**CITY OF EL PASO, TEXAS  
AGENDA ITEM  
DEPARTMENT HEAD'S SUMMARY FORM**

**A RESOLUTION APPROVING A DETAILED SITE DEVELOPMENT PLAN FOR LOT 1, BLOCK 367, VISTA DEL SOL UNIT NO. 80, 11409 CEDAR OAK DRIVE, CITY OF EL PASO, EL PASO COUNTY, TEXAS, PURSUANT TO SECTION 20.04.150. THE PENALTY IS AS PROVIDED FOR IN CHAPTER 20.24 OF THE EL PASO CITY CODE.**

PROJECT:  
AMPTX ELECTRIC, LP - NEW METAL BUILDING  
11409 CEDAR OAK DR.  
EL PASO TEXAS, 79936

**CASE NUMBER:** PZDS24-00031  
**CASE MANAGER:** Andrew Salloum, (915) 212-1603, [SalloumAM@elpasotexas.gov](mailto:SalloumAM@elpasotexas.gov)  
**PROPERTY OWNER:** AMPTX Properties, Inc.  
**REPRESENTATIVE:** SiteWork Engineering, LLC  
**LOCATION:** 11409 Cedar Oak Dr. (District 7)  
**PROPERTY AREA:** 1.18 acres  
**REQUEST:** Detailed Site Development Plan Approval per Ordinance No. 14649  
**RELATED APPLICATIONS:** None  
**PUBLIC INPUT:** None

## **ATTACHMENT 2**

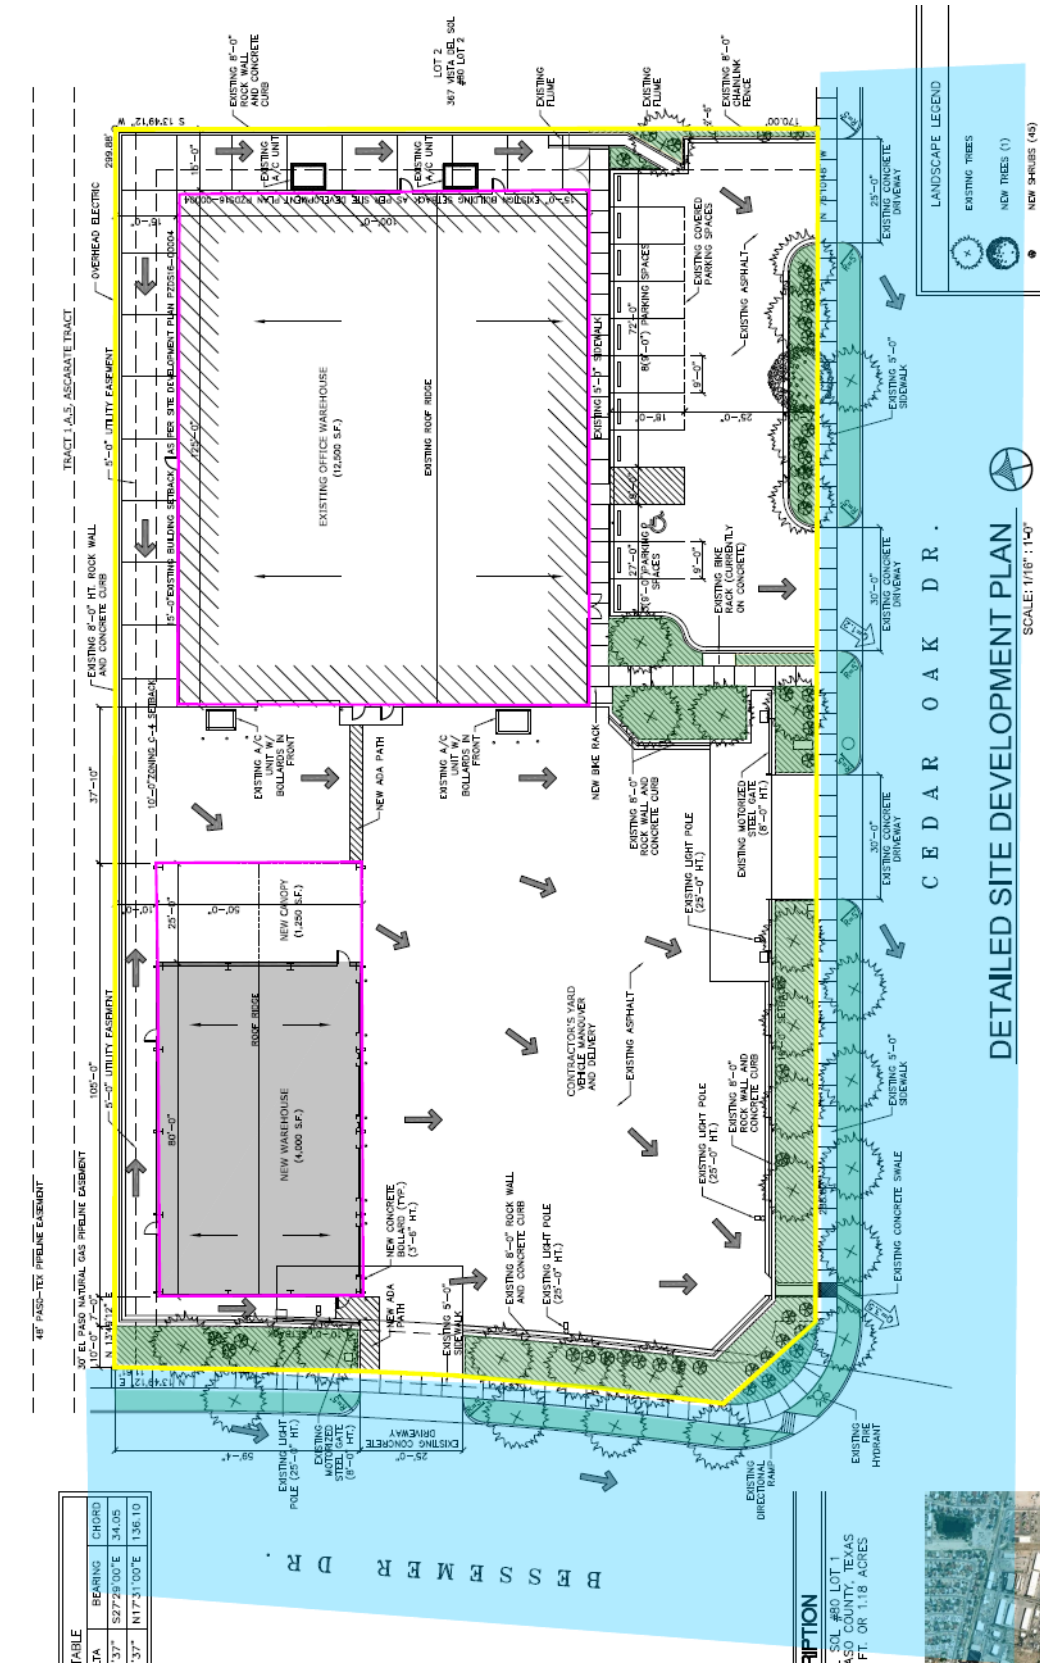
## **Planning and Inspections Department – Plan Review & Landscaping Division**

No objections to the proposed detailed site development plan.

At the time of submittal for building permit, the project will need to comply with all applicable provisions of the ICC, TAS and Municipal Code

There is an existing 8-inch diameter water main that extends along Cedar Oak Dr., located approximately 20-feet south of the north right-of-way line. This main is available for service.

There is an existing 8-inch diameter water main that extends along Bessemer Dr., located approximately 40-feet west of the east right-of-way line. This main is available for service.

EPWater-PSB records indicate an active 1-inch domestic water meter and a 6-inch fire line serving the subject property. The service address for these meters is 11409 Cedar Oak Dr.

Previous water pressure reading from fire hydrant #4712, located on the northeast corner of Cedar Oak Dr. and Bessemer Dr., has yielded a static pressure of 94 (psi), a residual pressure of 90 (psi), and a discharge of 1,384 (gpm). The owner should, for his own protection and at his own expense, install at the discharge side of each water meter a pressure regulator, strainer, and relief valve, to be set for pressure as desired by the customer. The Lot owner shall be responsible for the operation and maintenance of the above-described water pressure regulating device.

There is an existing 8-inch diameter sanitary sewer main that extends along Cedar Oak Dr., located approximately 35-feet south of the north right-of-way line. This main is available for service.

There is an existing 12-inch diameter sanitary sewer main that extends along Bessemer Dr., located approximately 25-feet west of the east right-of-way line. This main is available for service.

As per Municipal Code: new developments and redevelopments are required to maintain the pre-development hydrologic response in their post-development state as nearly as practicable in order to reduce flooding. The code also encourages the use of nonstructural storm water management such as the preservation of greenspace, water harvesting, and other conservation efforts, to the maximum extent practicable, per Chapter 19.19, Section 19.19.010, and Subparagraph A-2 & A-5.
